CUYAMA BASIN GROUNDWATER SUSTAINABILITY AGENCY STANDING ADVISORY COMMITTEE

Cuyama Basin Groundwater Sustainability Agency

Groundwater Sustainability Plan Update

Figure 2.2-24:2011-2018 Average Well Measurements of Total Dissolved Solids, mg/L
 Cuyama Basin Groundwater Sustainability Agency
 Cuyama Valley Groundwater Basin Groundwater Sustainability Plan
 August 2018

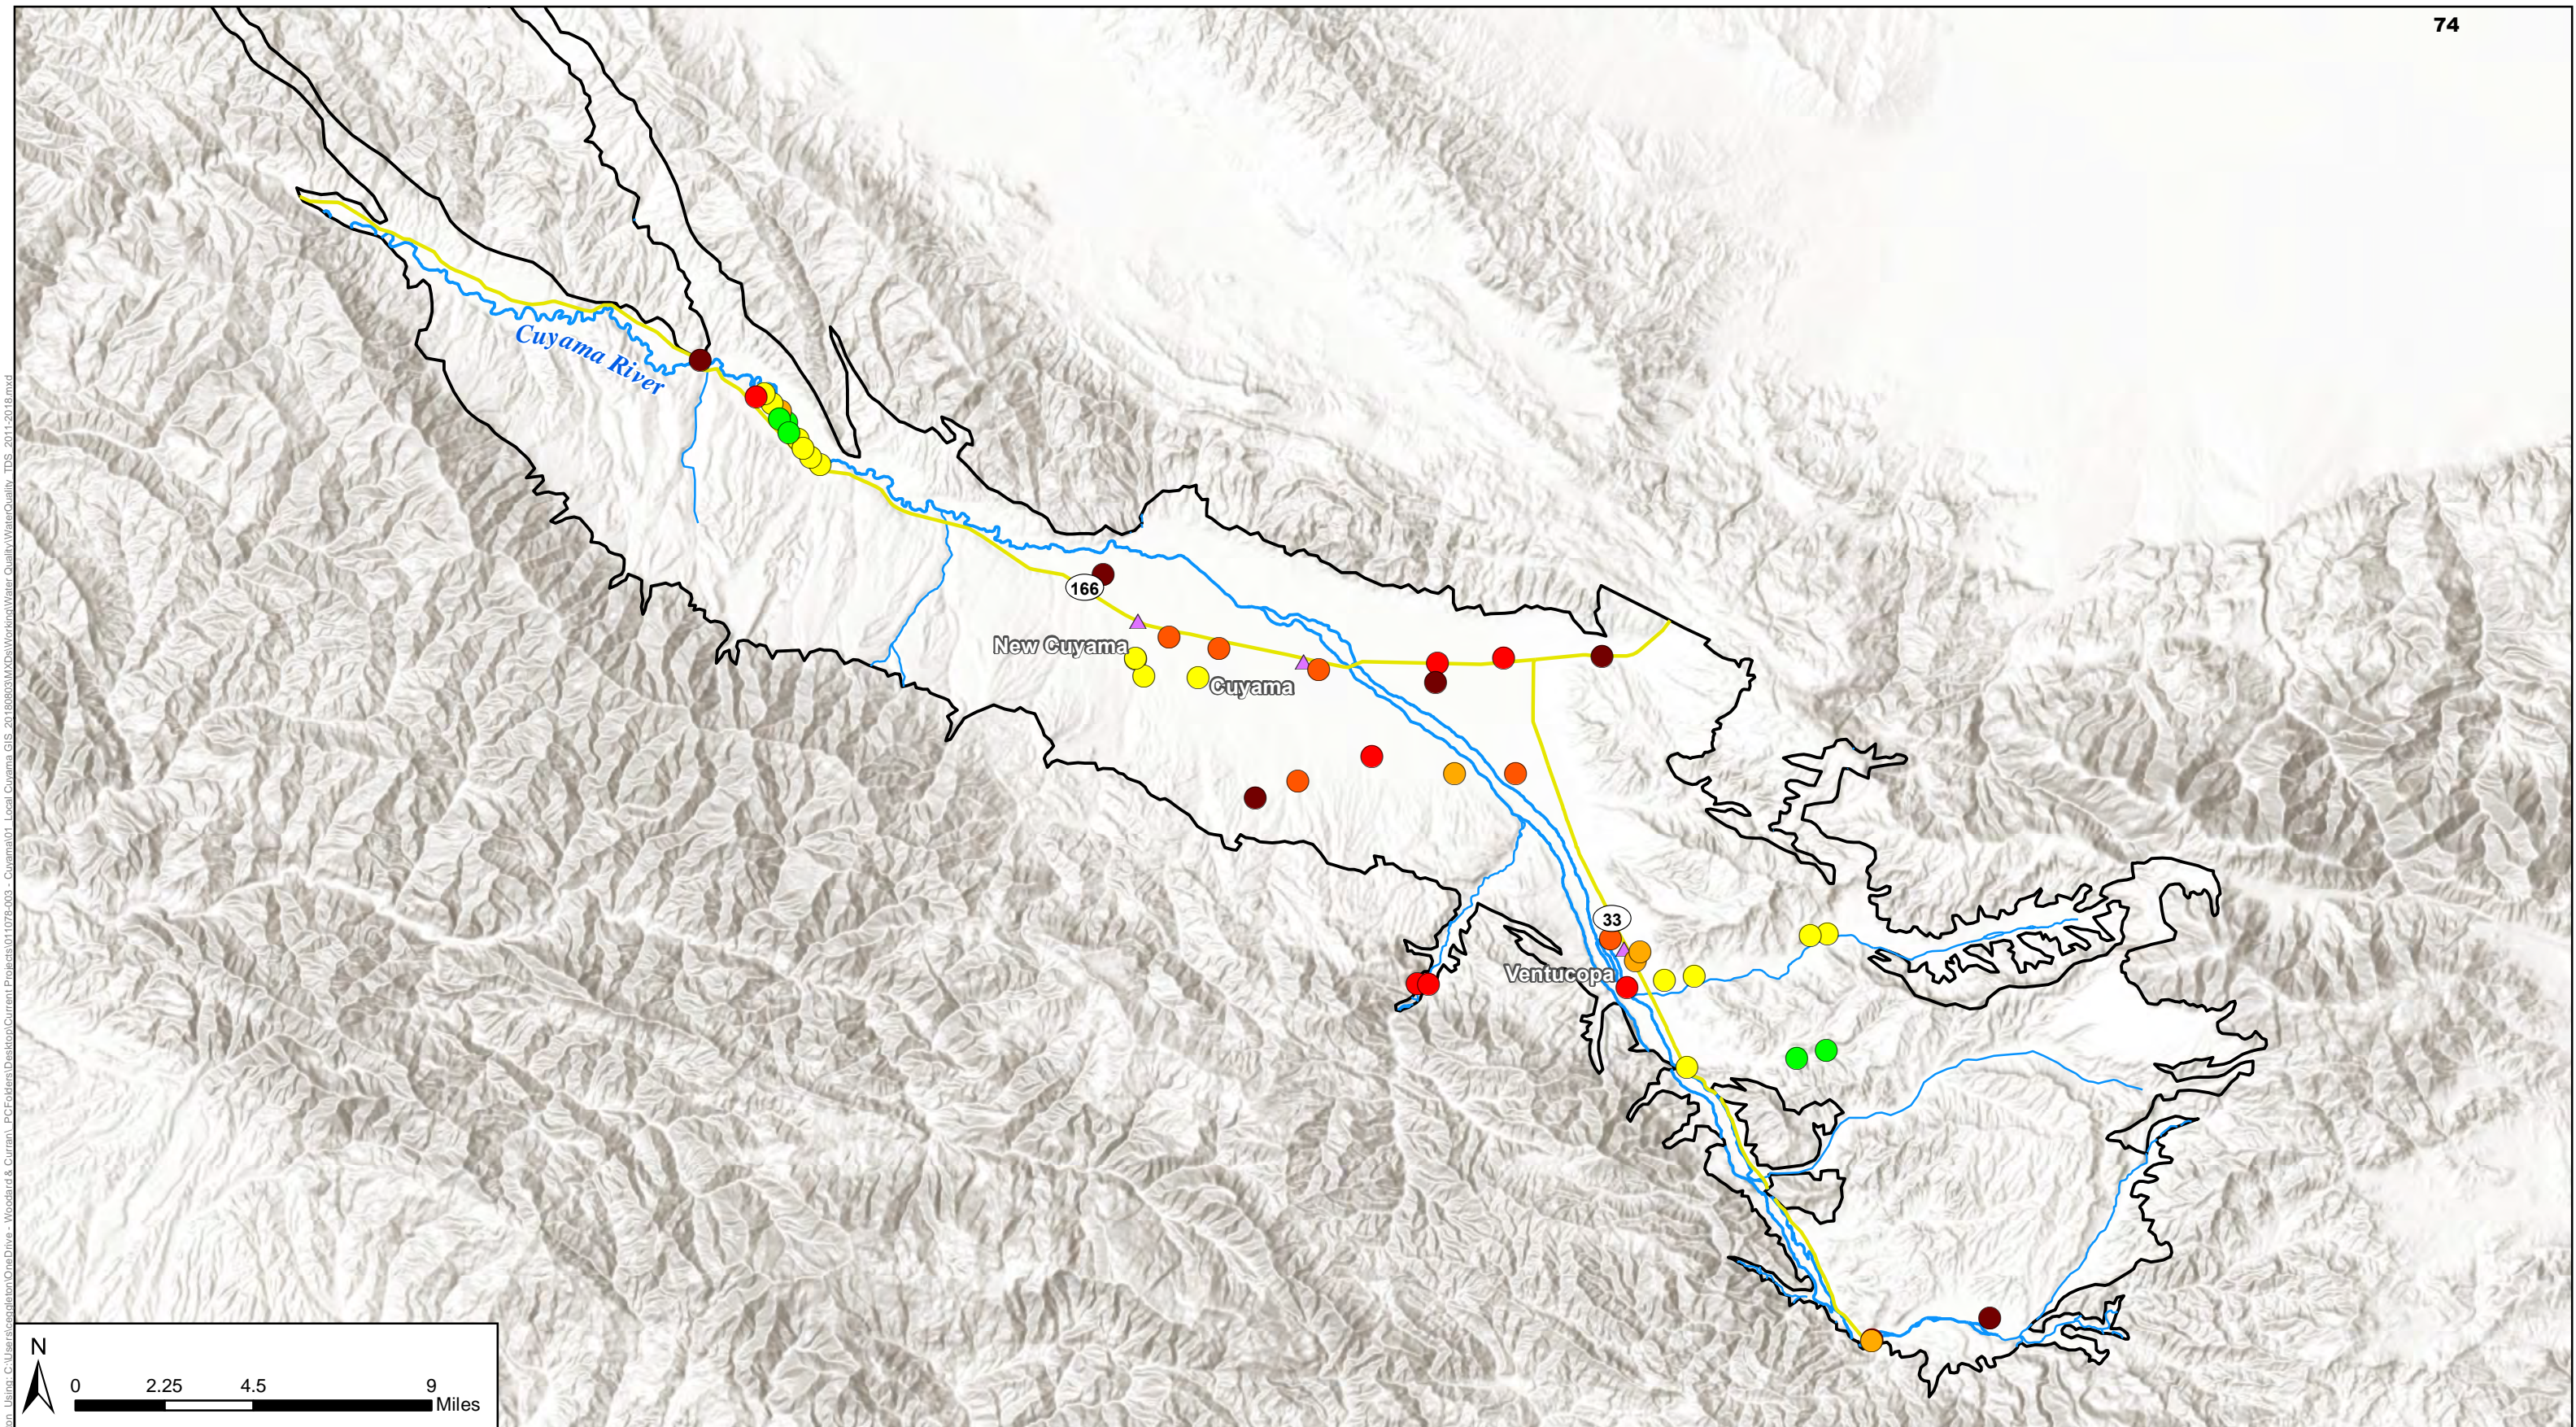
102	Cathy Martin	County of San Luis Obispo	Figure 2.2-24	N/A	N/A		Place label on figure (Quatal Canyon, and along the Cuyama River between Cottonwood Canyon and Schoolhouse Canyon)	These are labeled on Figure 2.2-1
103	Cathy Martin	County of San Luis Obispo	Figure 2.2-25	N/A	N/A		Place label on figure (Quatal Canyon)	This is labeled on Figure 2.2-1

174	Matt Young, Matt Scudato, & Fray Crease	Santa Barbara County Water Agency	2.2.7 Data Analysis			Figure 2.2-24 shows TDS of groundwater	Note: Additional data for west end collected July 2018 will be available soon.	Comment noted. Due to budget and schedule constraints, data provided after June 2018 will not be incorporated into the current version of the plan.
175	Matt Young, Matt Scudato, & Fray Crease	Santa Barbara County Water Agency	2.2.7 Data Analysis			Multiple years of collected data were used	Where is the comparison? Figure 2.2-23 (1966 data) shows high (>2000mg/L) TDS for wells on west end N of river. These are very shallow and recharged by the river. Figure 2.2-24 shows wells directly S of river with low TDS. These are new deep wells. They shouldn't be compared as the same unit. The map alludes to the fact that they are. That possibly the quality has improved	The text does not make a direct comparison because there is insufficient data to make specific conclusions regarding how TDS may have changed over time.

Figure 2.2-25: Cuyama Groundwater Basin Historic TDS Levels in Selected Wells
 Cuyama Basin Groundwater Sustainability Agency
 Cuyama Valley Groundwater Basin Groundwater Sustainability Plan
 August 2018

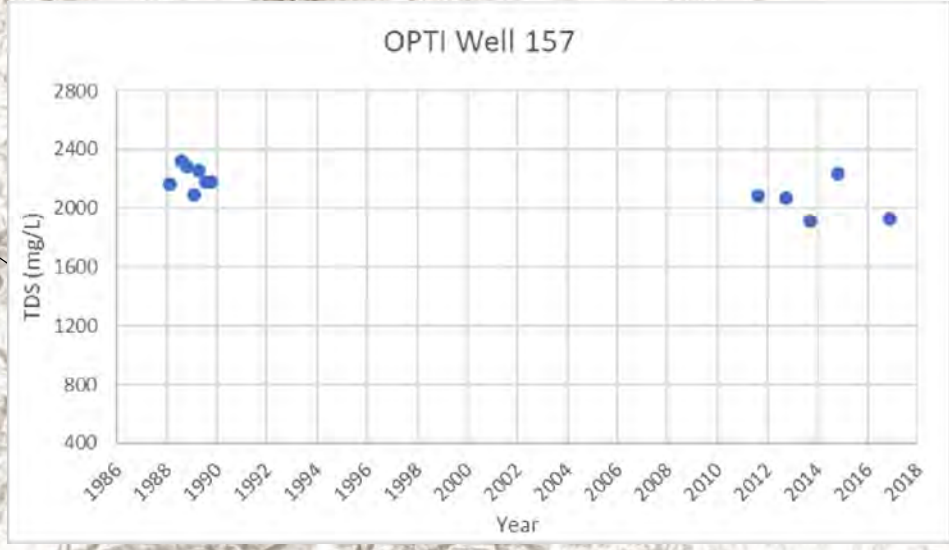
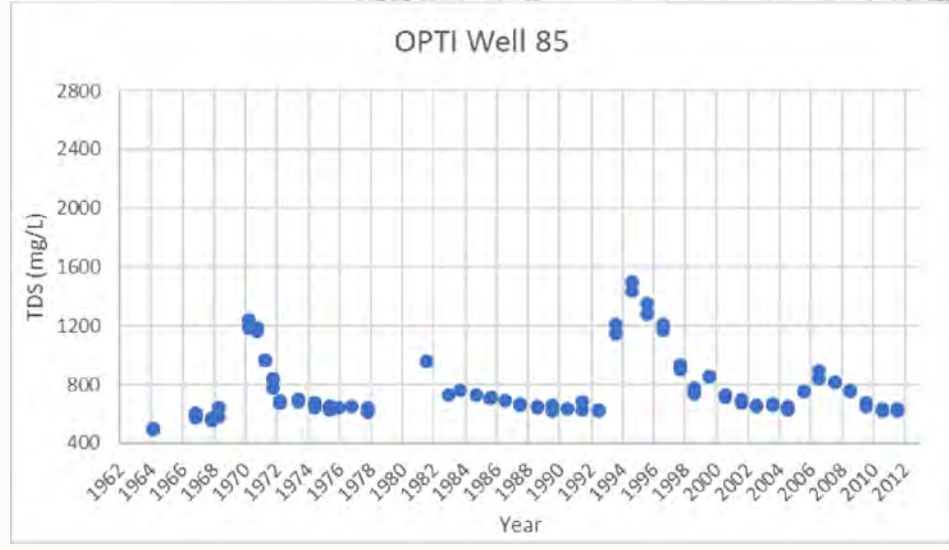
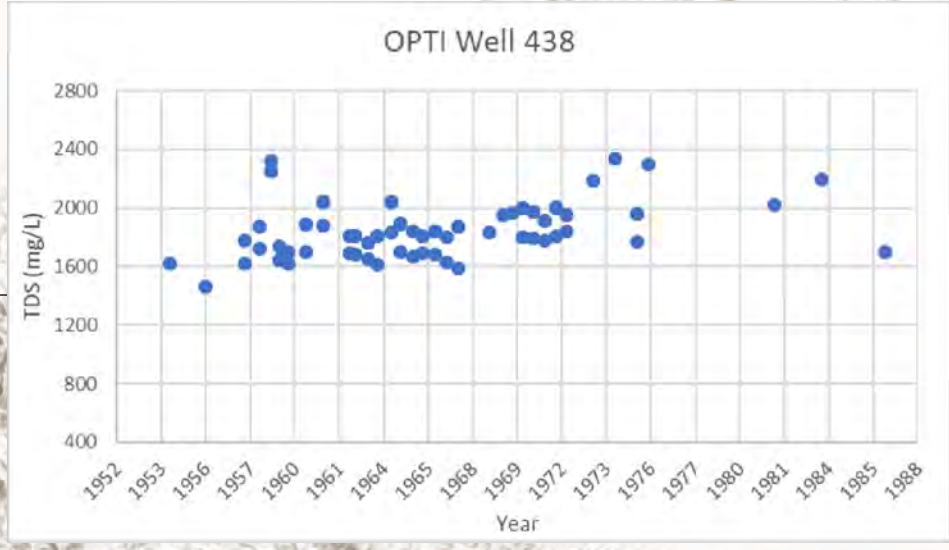
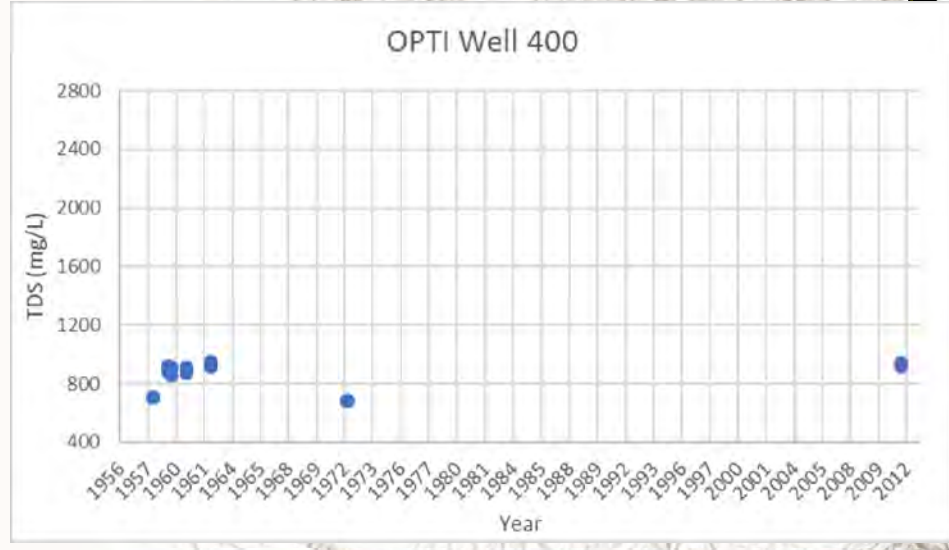
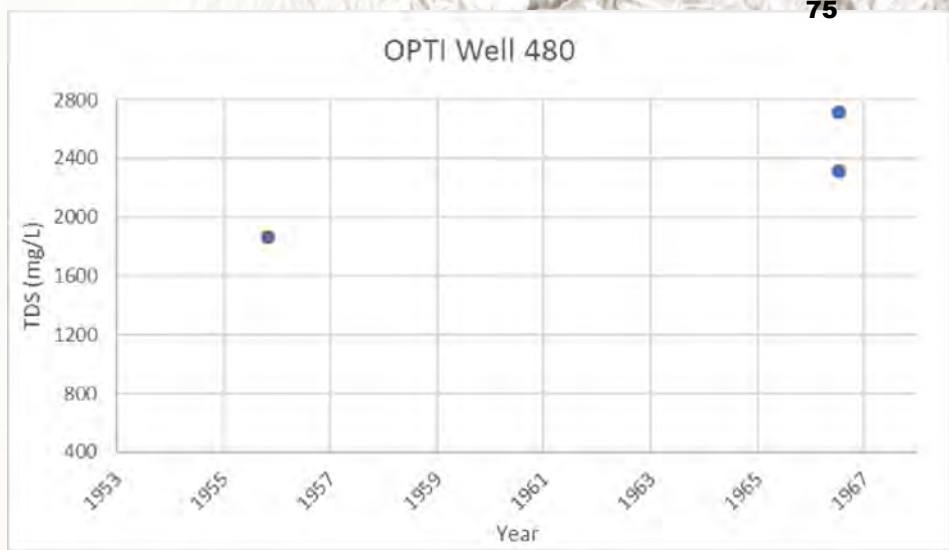
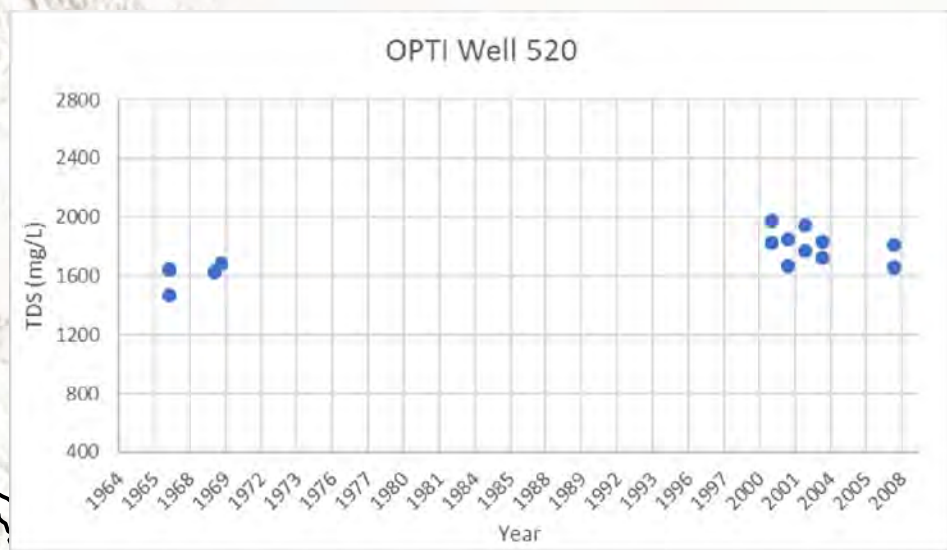
176	Matt Young, Matt Scudato, & Fray Crease	Santa Barbara County Water Agency	Figure 2.2-25				Include a line showing the MCL on the figure	MCL lines have been added to the figure.
177	Matt Young, Matt Scudato, & Fray Crease	Santa Barbara County Water Agency	2.2.7 Data Analysis			Figure 2.2 28 shows arsenic measurements	USGS data indicate 4 of the 33 wells were >10 Only 25 wells used in this study. Why the discrepancy and why were the 4 wells with >10 not used? Please elaborate on data selection used for this analysis.	The text and figure have been reviewed and updated.
178	Matt Young, Matt Scudato, & Fray Crease	Santa Barbara County Water Agency	2.2.7 Data Analysis			Figure 2.2-28 shows arsenic measurements	What about the CSD? They treat for arsenic.	The CSD did not provide any arsenic data.
179	Matt Young, Matt Scudato, & Fray Crease	Santa Barbara County Water Agency	2.2.7 Data Analysis			Figure 2.2-29 shows that most of these sites	Describe for the reader what this means – leaks from storage tanks?	The text has been revised for clarity.
